SECTION 92 DOCUMENTS – VOLUME 4

**5 REEVES ROAD, PAKURANGA HEIGHTS (EB2);
207 TI RAKAU DRIVE, PAKURANGA HEIGHTS
(EB3R)**

FINAL S92 RESPONSE FOR EB3R

Re. Response to Council further information requests for the EB3R Application Package

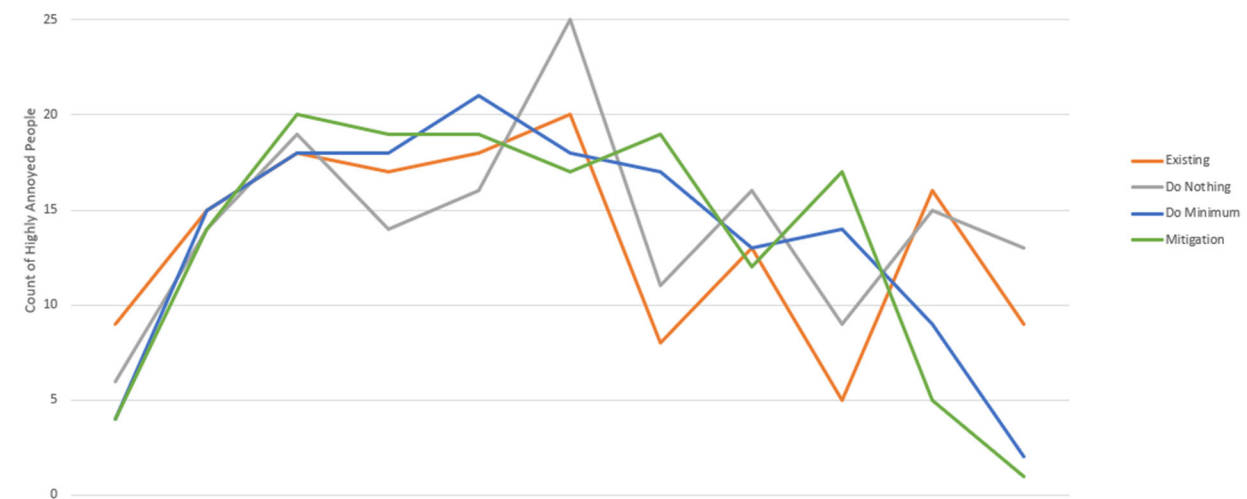
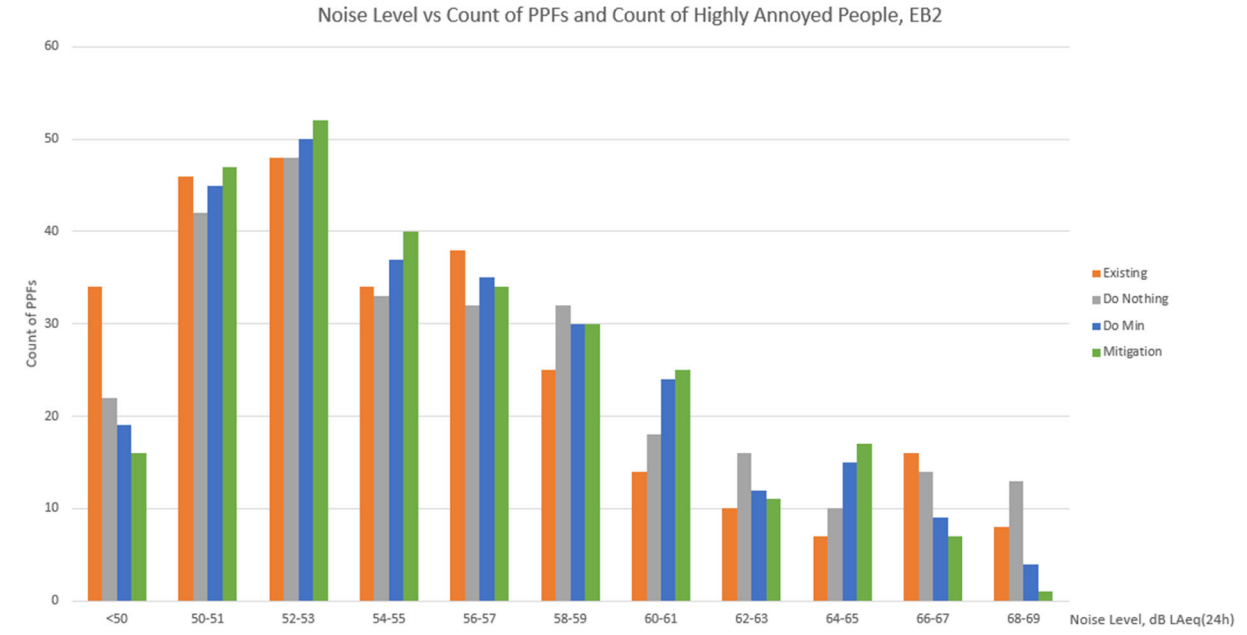
Request partly satisfied. The response confirms that the noise models have been adjusted to reflect the different speed environments appropriately. However, the updated data is shown only in lengthy tables by-receiver as an appendix to the response. The categorisation and summaries of this data is an important factor in the overall assessment of noise effects. Such summaries of the original data can be found in the original assessment in many places. For example, table 6-1, the text in section 6.1, right through section 6.2, very significantly at Figures 7 and 8 and the accompanying text, much of section 6.3 and numerous individual statements throughout the report including in the conclusions. The revised predictions need to be integrated into the original noise report and all consequential changes made. The Appendices showing the noise level predictions and categorisation of PPFS also need updating. This is critical to allow the submitters and decision makers to understand the effects.

Using the regression equation above and the population estimations, the count of people potentially highly annoyed per 2 dB band from 50 dB L_{Aeq} to 70 dB L_{Aeq} has been estimated for the noise modelling scenarios. The results are summarised in the table and figure below.

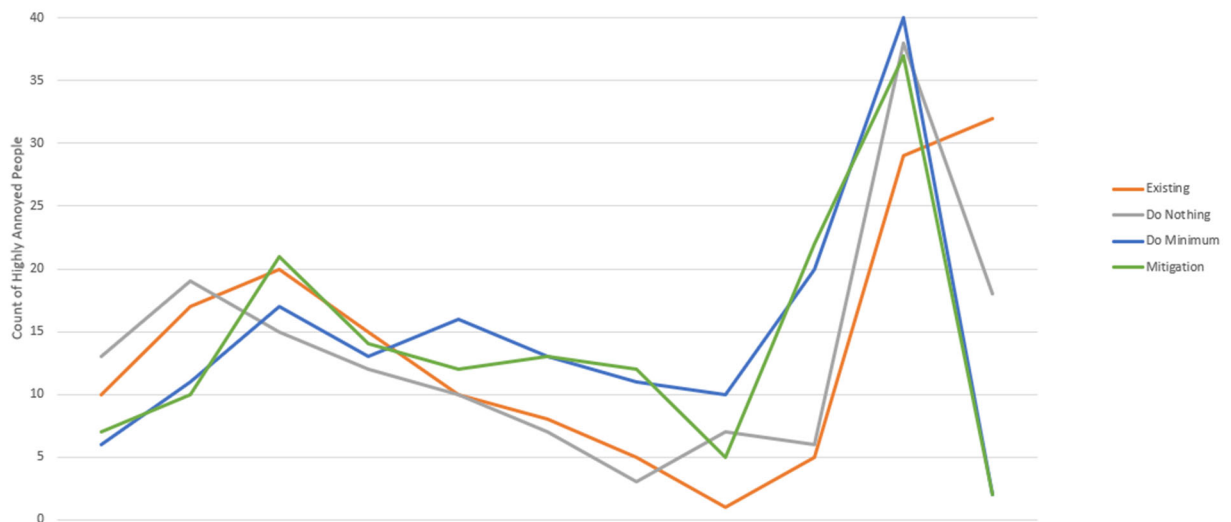
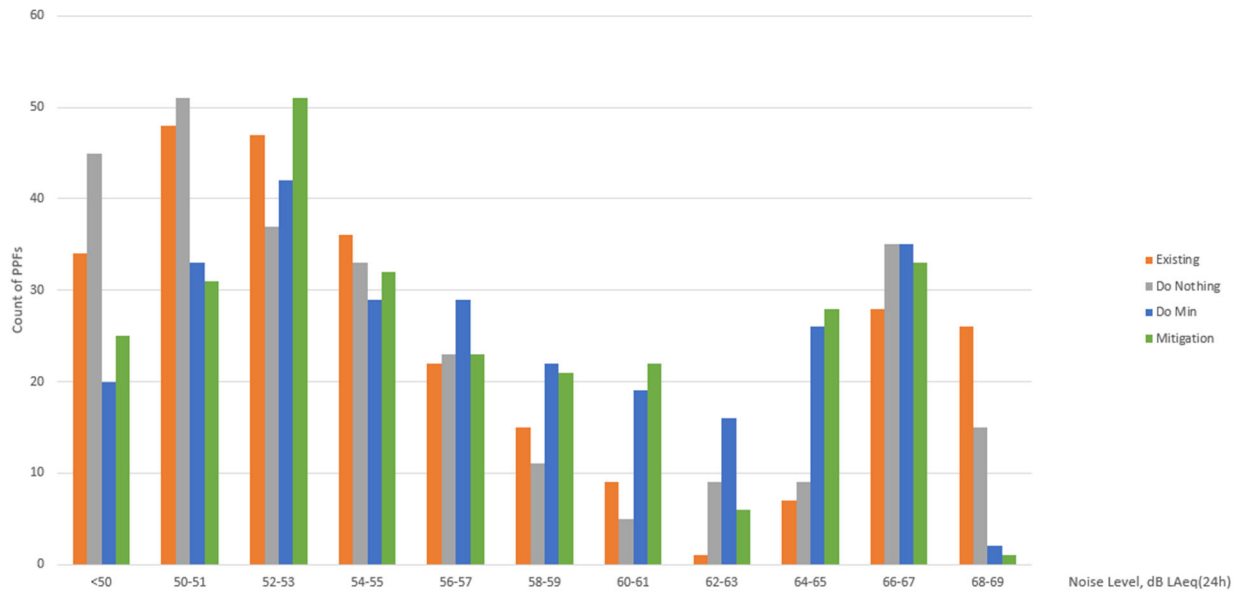
Request partly satisfied. The response confirms that the noise models have been adjusted to reflect the different speed environments appropriately. However, the updated data is shown only in lengthy tables by-receiver as an appendix to the response. The categorisation and summaries of this data is an important factor in the overall assessment of noise effects. Such summaries of the original data can be found in the original assessment in many places. For example, table 6-1, the text in section 6.1, right through section 6.2, very significantly at Figures 7 and 8 and the accompanying text, much of section 6.3 and numerous individual statements throughout the report including in the conclusions. The revised predictions need to be integrated into the original noise report and all consequential changes made. The Appendices showing the noise level predictions and categorisation of PPFS also need updating. This is critical to allow the submitters and decision makers to understand the effects.

Using the regression equation above and the population estimations, the count of people potentially highly annoyed per 2 dB band from 50 dB L_{Aeq} to 70 dB L_{Aeq} has been estimated for the noise modelling scenarios. The results are summarised in the table and figure below.
